# Site Accessibility Evaluation

**Mackenzie Park**  
**3111 State St**  
**Santa Barbara, CA 93105**  
**Accessibility Evaluation**  
**Inspection Date: 08/17/2023**  
**Inspectors: Scott Saddlemire**

**Report Date: 11/03/2023**

### Finding: 1

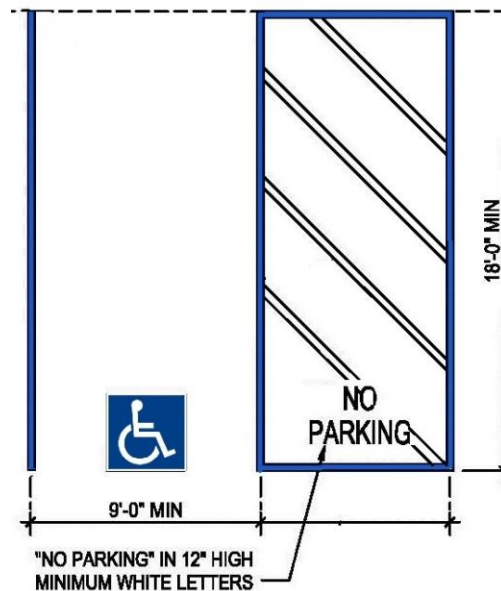
The required "No Parking" marking on the surface of the access aisle is faded.

Markings are not legible

Maintenance is required for all accessible parking striping.

The hatched lines should be white when over black asphalt with the blue boarder. The NO PARKING needs to be legible and do not run the hatched line through the NO PARKING letters

### Finding: 2

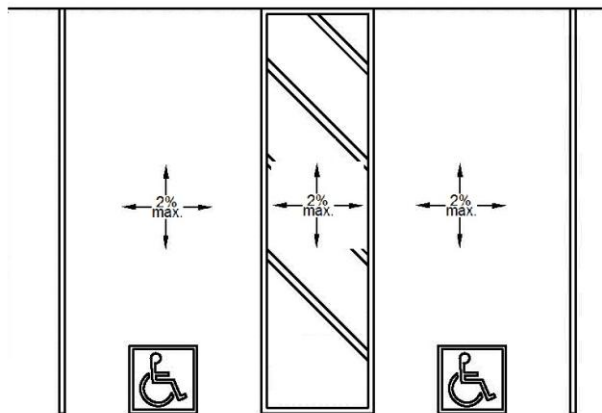
The cross slopes (narrow dimension) and/or running slopes (long dimension) of the accessible stall exceeds 2%.

over 9% slope due to uplifting of  
the pavers

repair the parking lot and access aisle surface to make slopes in all direction 2% or less

### Finding: 3

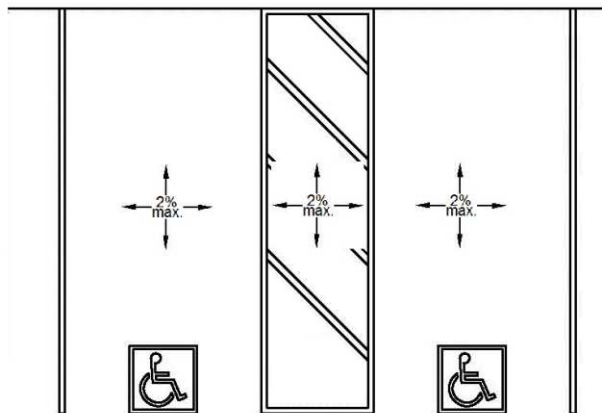
The cross slopes (narrow dimension) and/or running slopes (long dimension) of the access aisle exceeds 2%.

repair the parking lot and access aisle surface to make slopes in all direction 2% or less

### Finding: 4

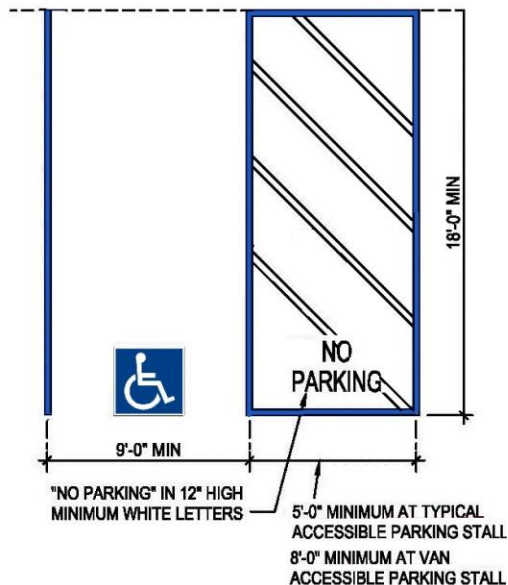
old parking stall markings remain

old parking stall markings  
remain

remove all old parking stall markings

### Finding: 5

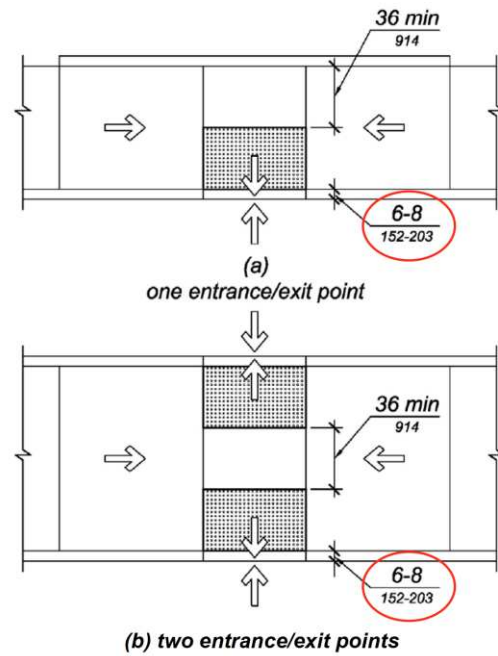
The detectable warning is not located on the turning space and/or is not within the allowable distance from the Demarcation line at the face of the curb.

detectable warnings should be  
at the openings

The detectable warnings are at the wrong location for this parallel ramp. They should be in the openings leading to the vehicle way.

### Finding: 6

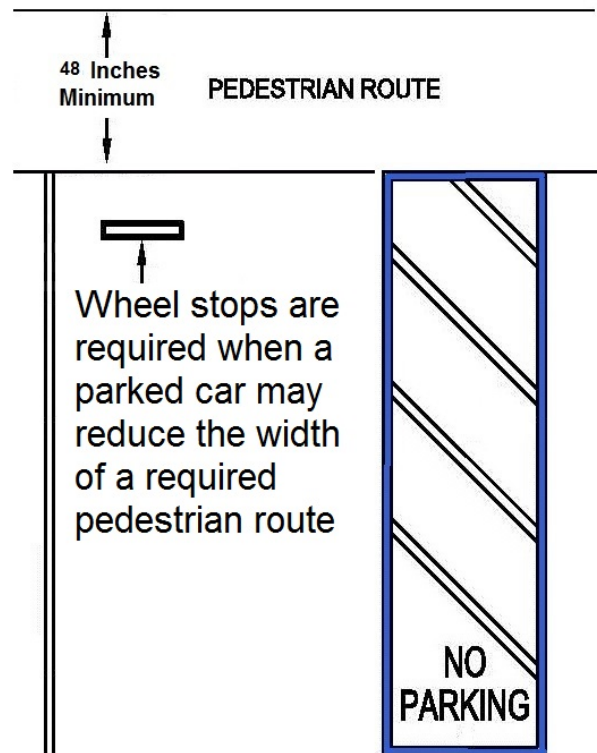
Parked vehicles reduce the required width of the accessible route.

no wheel stops

Install wheel stops at all parking stalls where parked vehicles can reduce the required width of the walkway

### Finding: 11

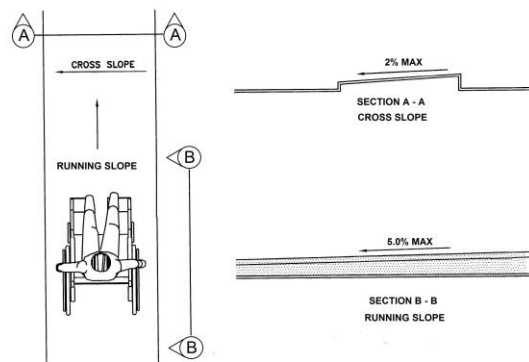
The accessible path of travel between the building entrance and the accessible parking has cross slopes greater than 2%.

cross slope

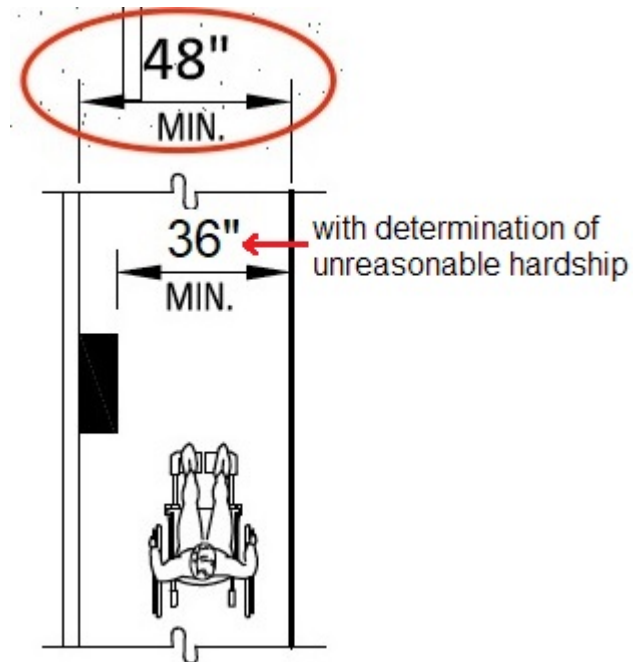
The route of travel does not provide the required minimum width.

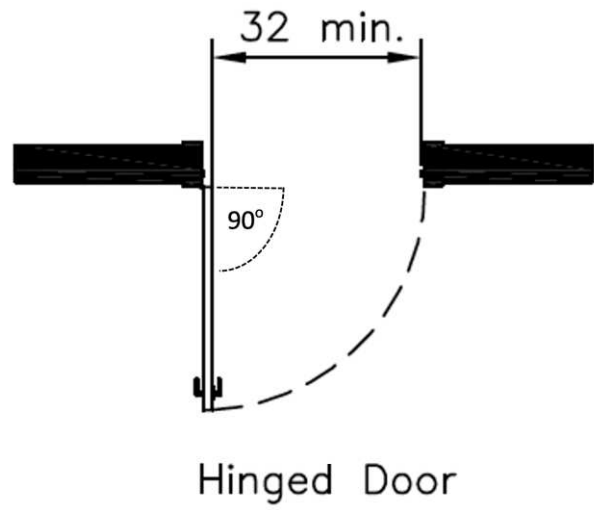
The door opening does not provide at least 32 inches between the face of the door and the opposite stop.

Add City Employees only sign  
Door threshold is non compliant
